Amendments to the Drawings

Attorney Docket No. 127976-1000

App. No.: 10/664,737
Reply to Office Action of 12/07/04
Annotated Sheet Showing Changes

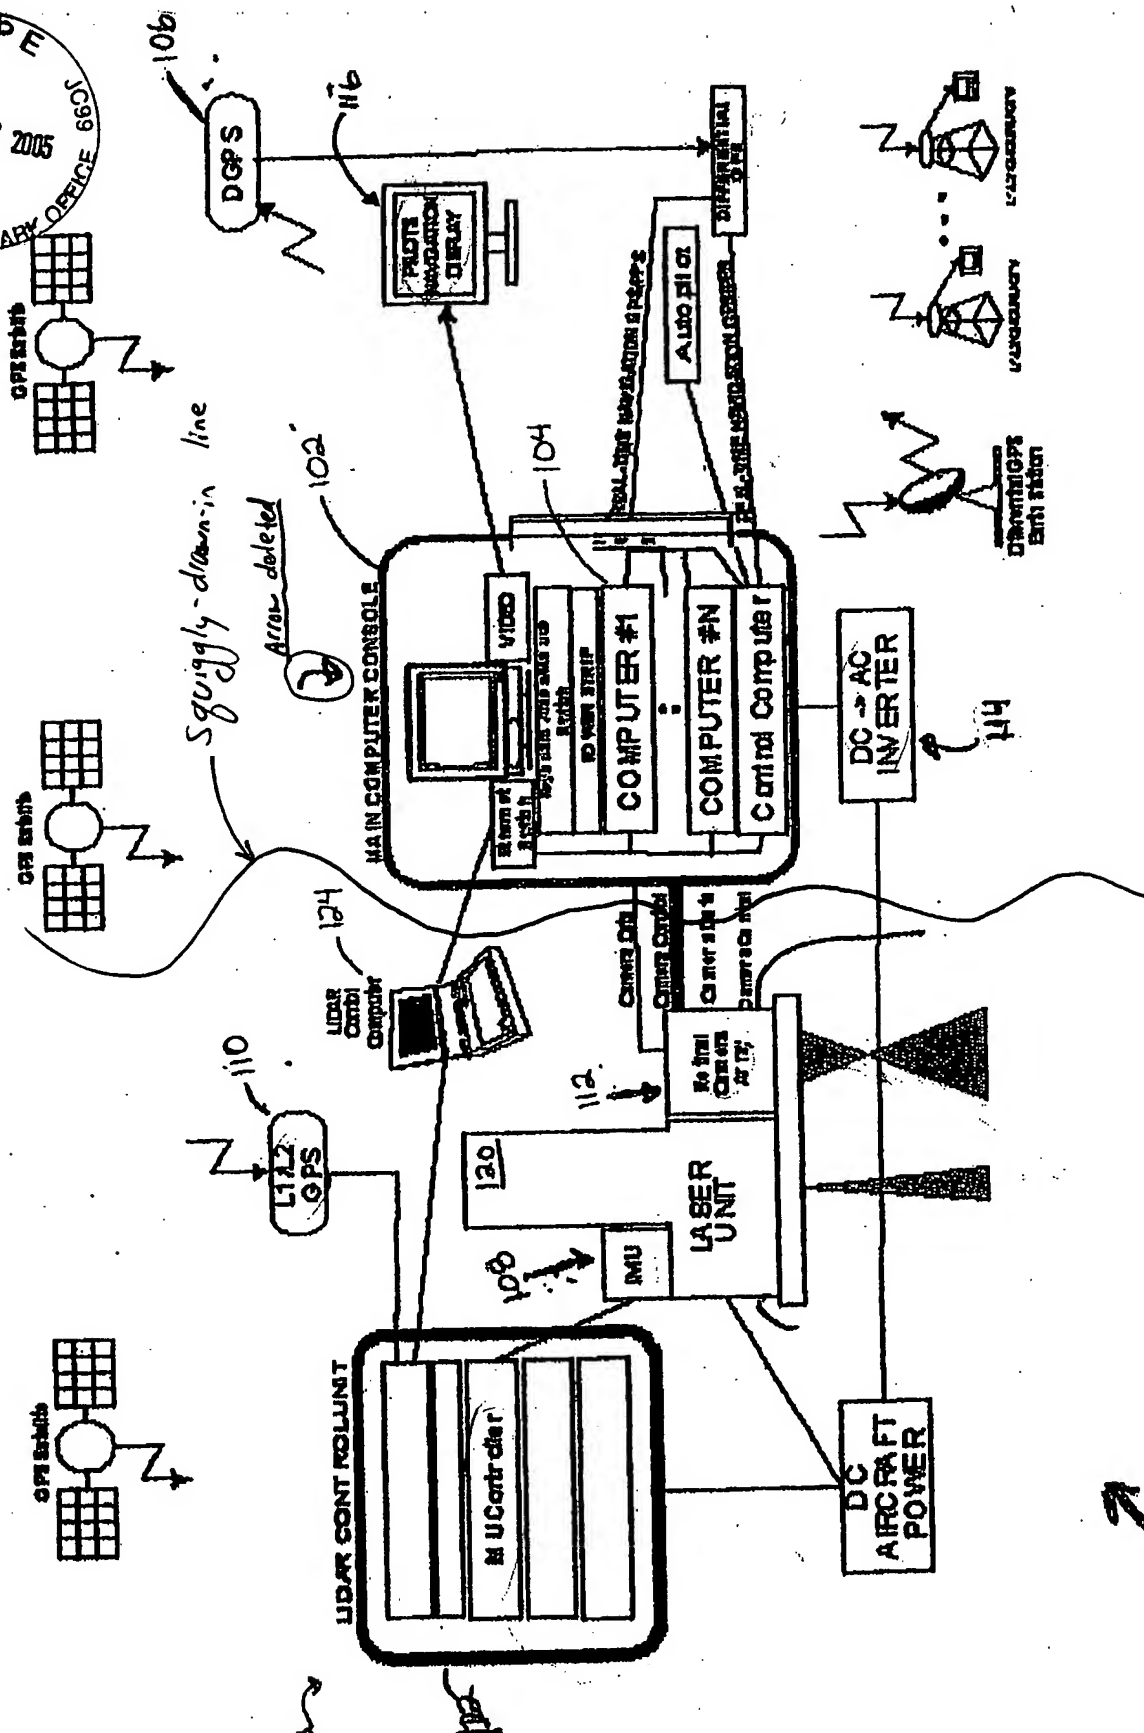
The attached sheet of drawings includes changes to Figures 1-18. The sheet that includes Figure 1 now replaces the original sheet that included Figure 1. In Figure 1, the lines connecting and identifying certain representational components have been repositioned for reasons of clarity. In Figure 1, the shape of the boxes have been changed and repositioned for reasons of clarity and stylistic preference. Additionally, Applicant has deleted some of the words in Figure 1, without prejudice and for reasons of clarity. No new matter has been added to Figure 1. Additionally, the arrow pointing to the block previously labeled “main computer console” has been deleted. Accordingly, Applicant respectfully requests the withdrawal of the objection to Figure 1.

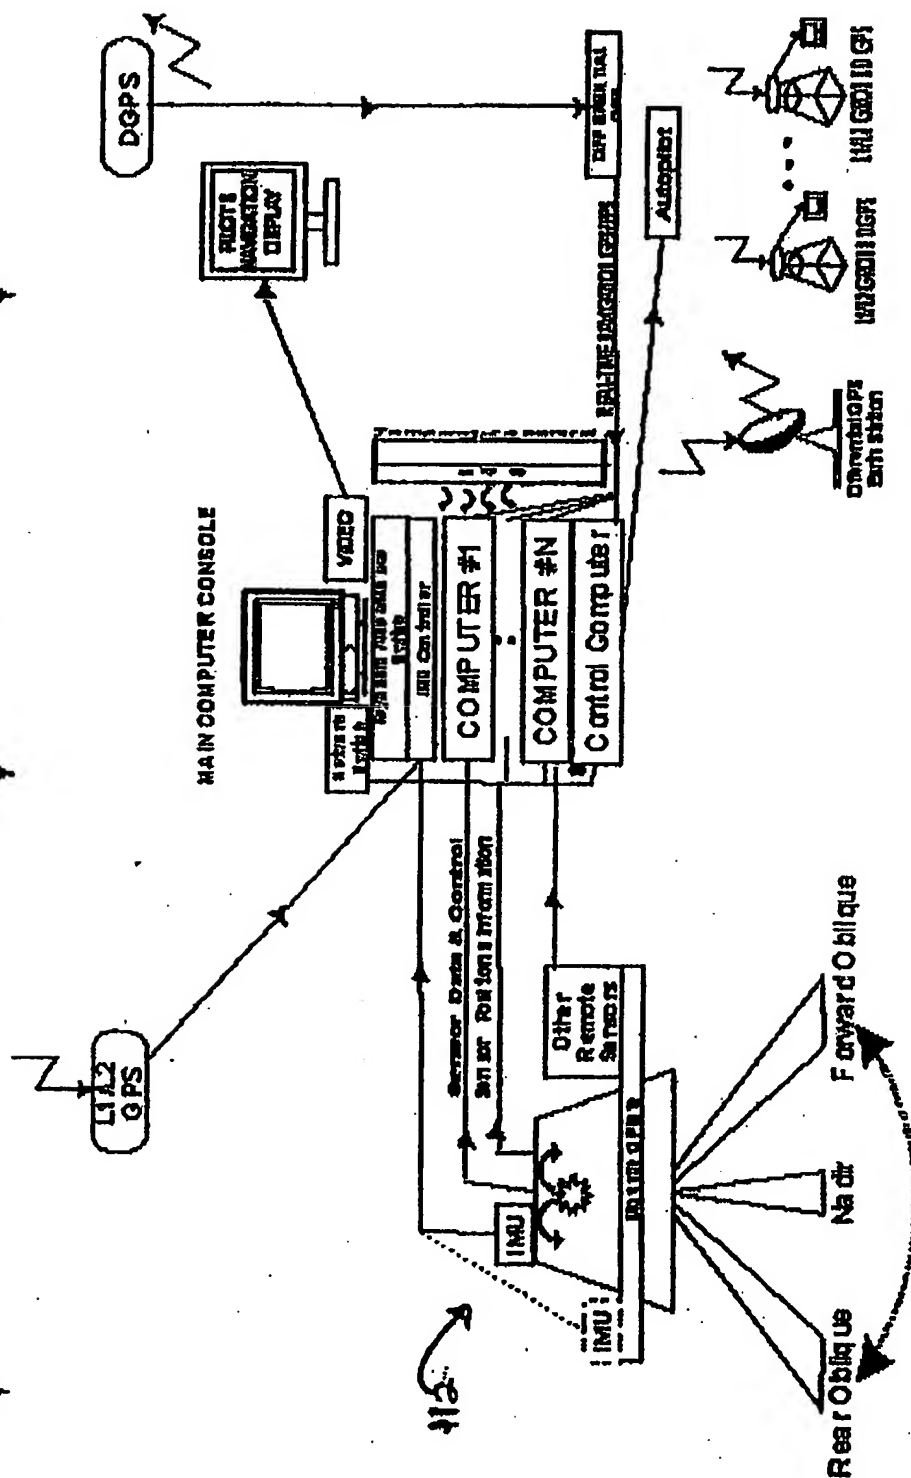
The sheets that includes Figure 2 now replaces the original sheet that included Figure 2. In Figure 2, the lines connecting and identifying certain representational components have been repositioned for reasons of clarity. No new matter has been added to Figure 2.

FIG. 3

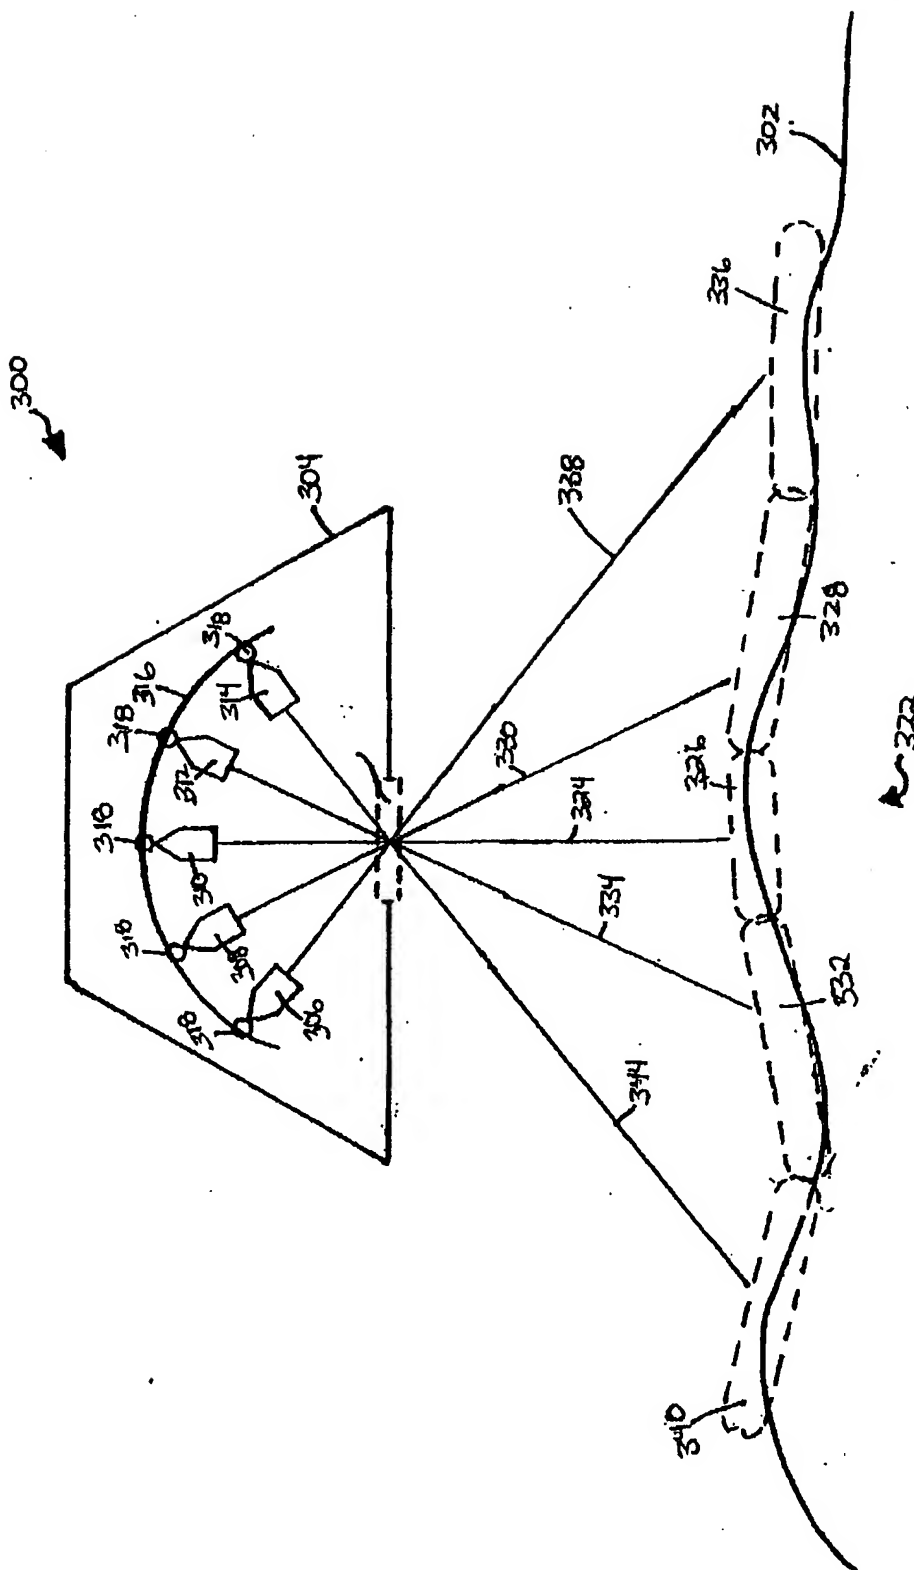
The sheets that includes Figures 3 and 4 now replaces the original sheet that included Figure 3 and the original sheet that included Figure 4. In Figures 3 and 4, the lines connecting

and identifying certain representational components have been repositioned for reasons of clarity. No new matter has been added to Figures 3 and 4.

FIG. 7

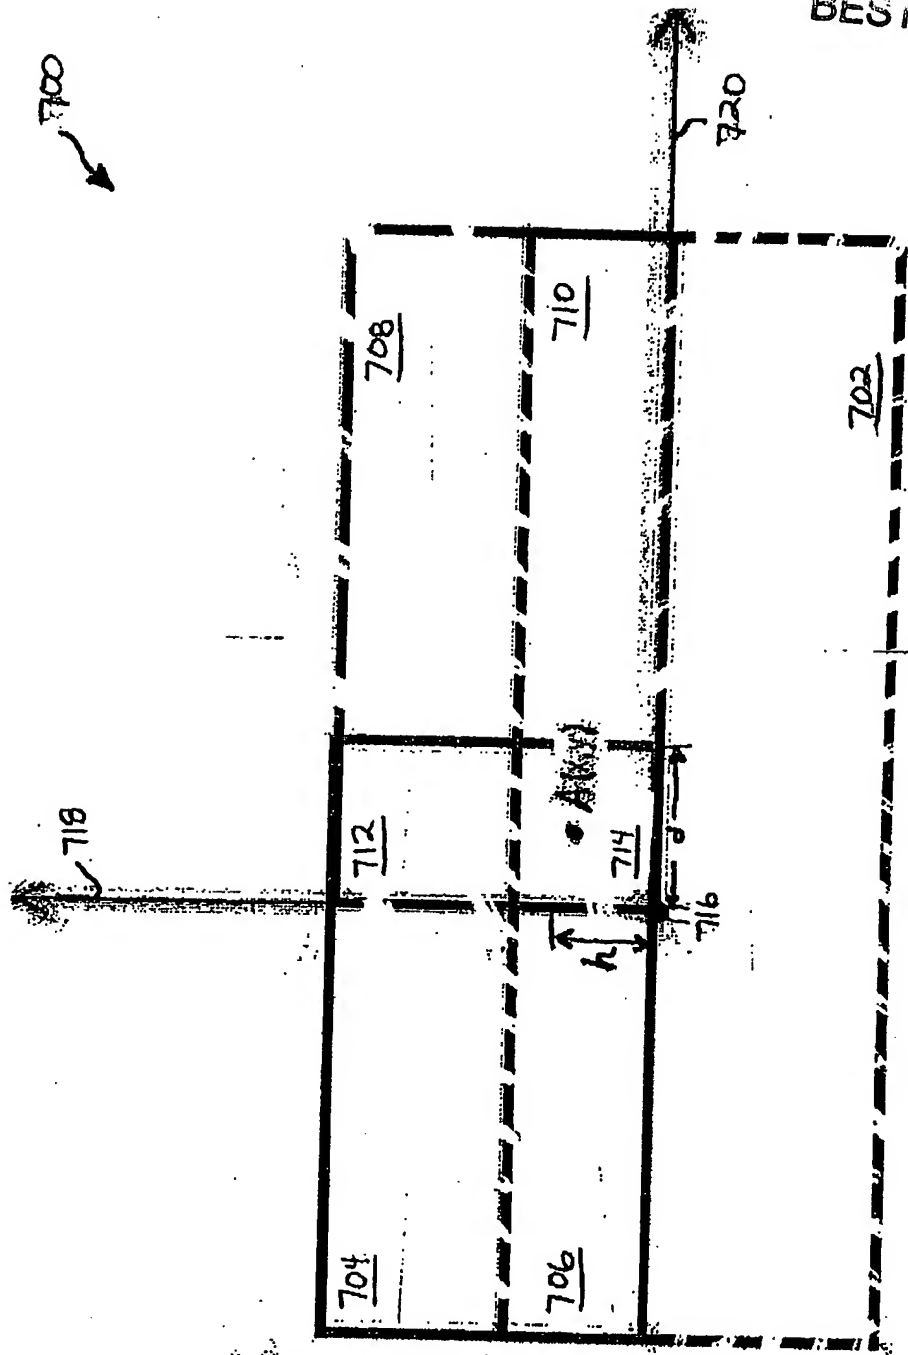
The sheets that includes Figures 6 and 7 now replaces the original sheet that included Figure 6 and the original sheet that included Figure 7. In Figures 6 and 7, the lines identifying certain representational components have been repositioned for reasons of clarity. No new matter has been added to Figures 6 and 7.

FIG. 8

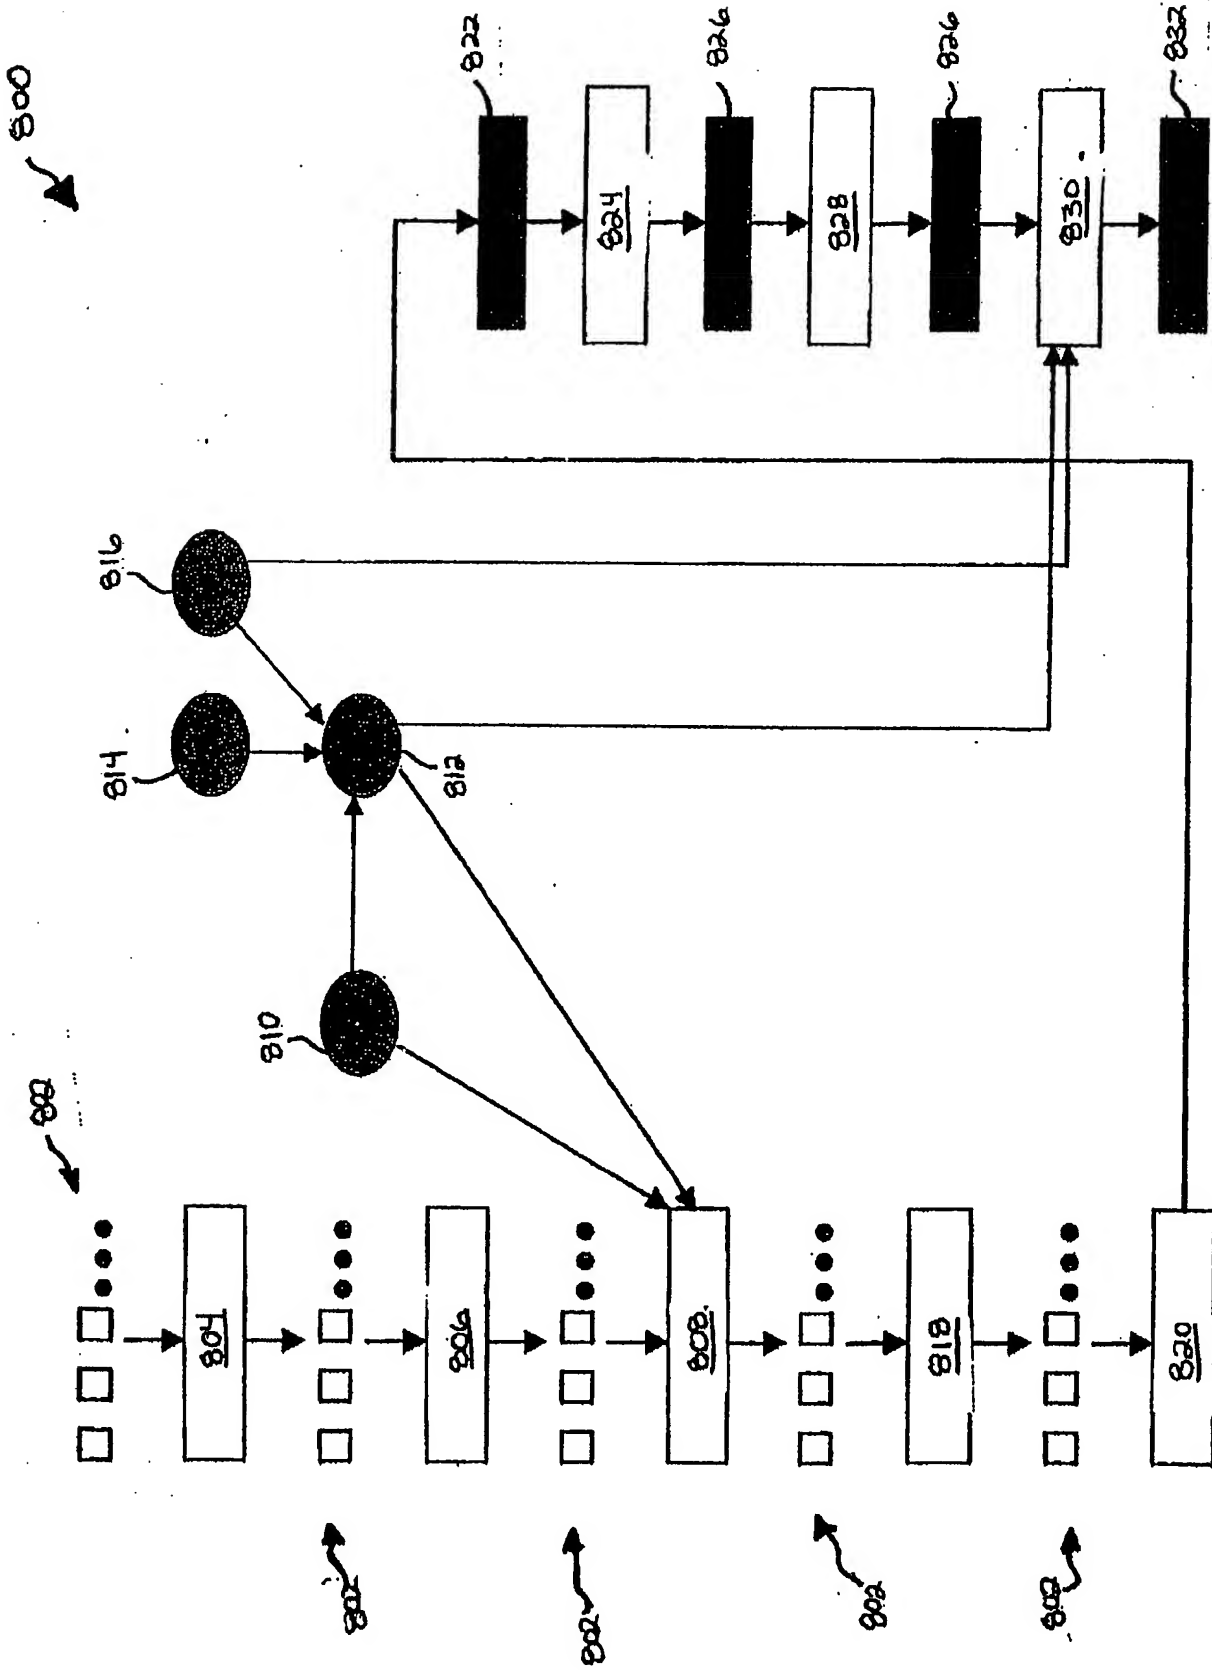
The sheet that includes Figure 8 now replaces the original sheet that included Figure 8. In Figure 8, the lines identifying certain representational components have been repositioned for reasons of clarity. No new matter has been added to Figure 8.

FIGURE 10

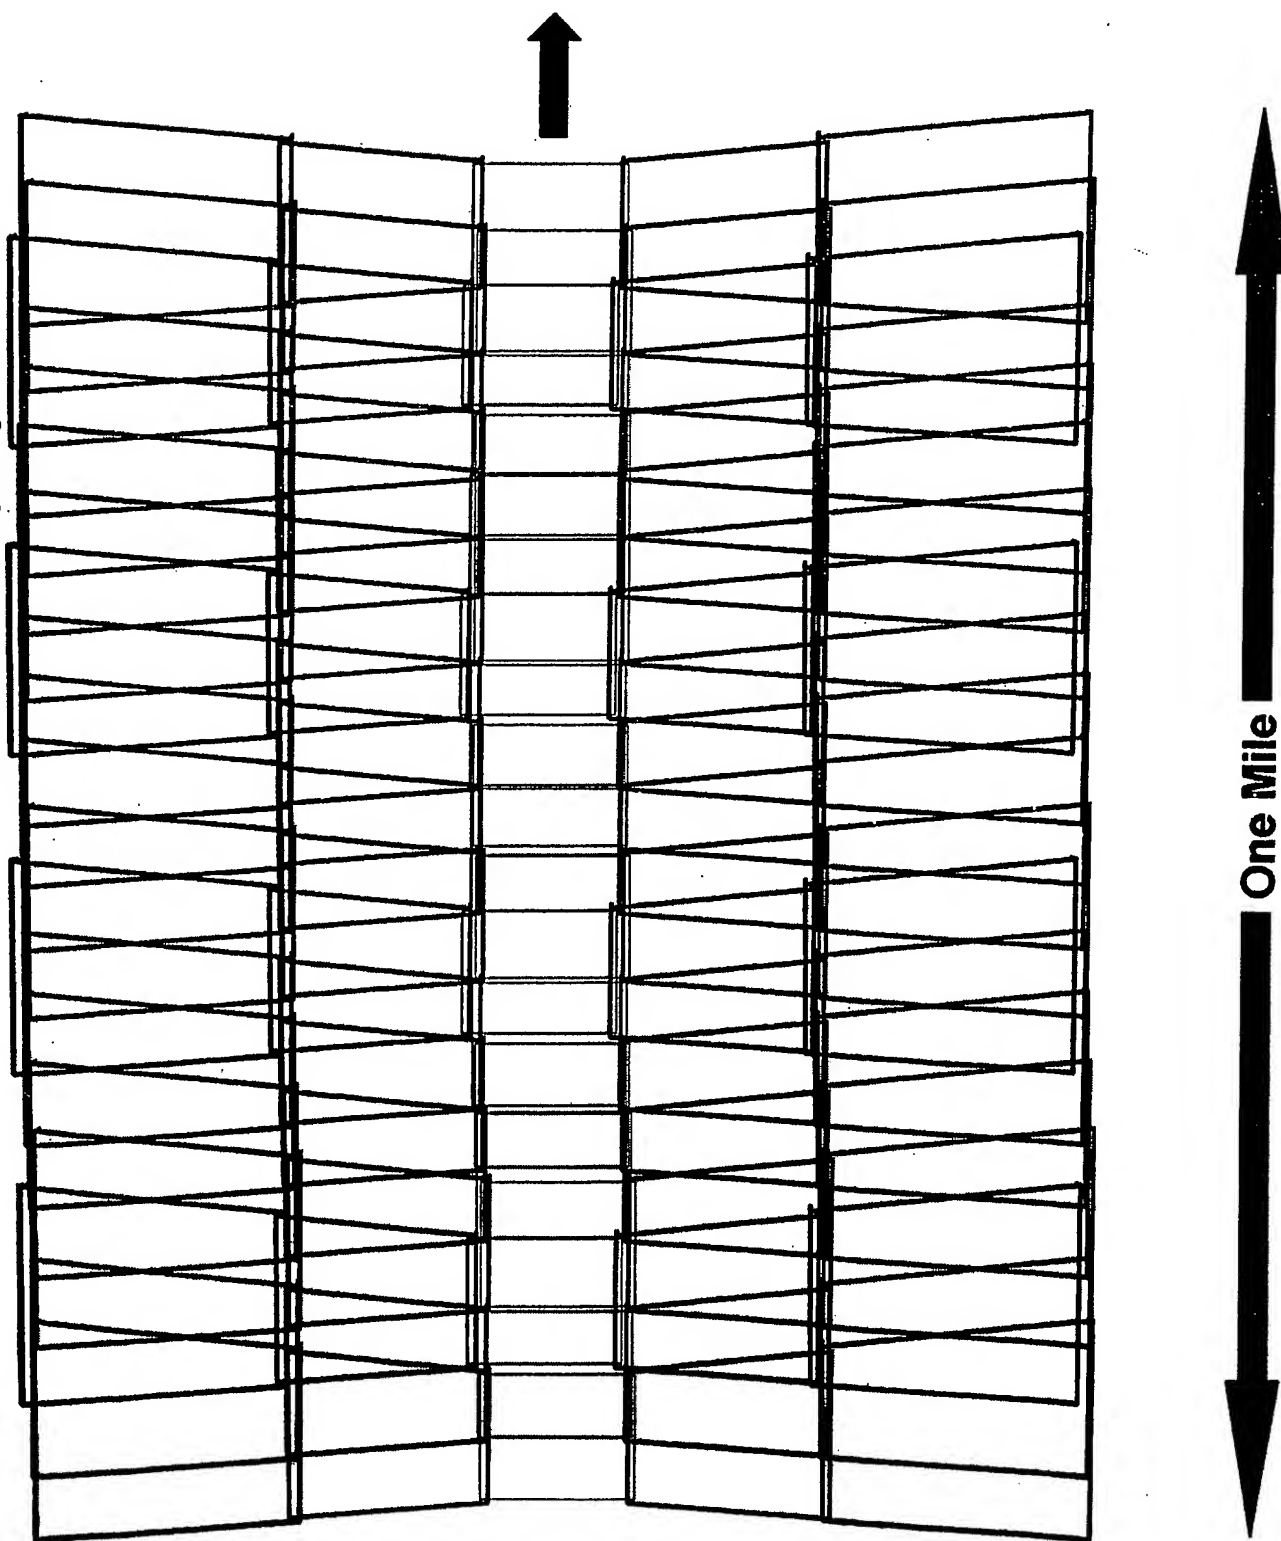
The sheet that includes Figure 10 now replaces the original sheet that included Figure 10. In Figure 10, the lines connecting and identifying certain representational components have been repositioned for reasons of clarity. In Figure 10, the shape of the boxes have been changed and repositioned for reasons of clarity and stylistic preference. Additionally, Applicant has deleted

some of the words in Figure 10, without prejudice and for reasons of clarity. No new matter has been added to Figure 10.
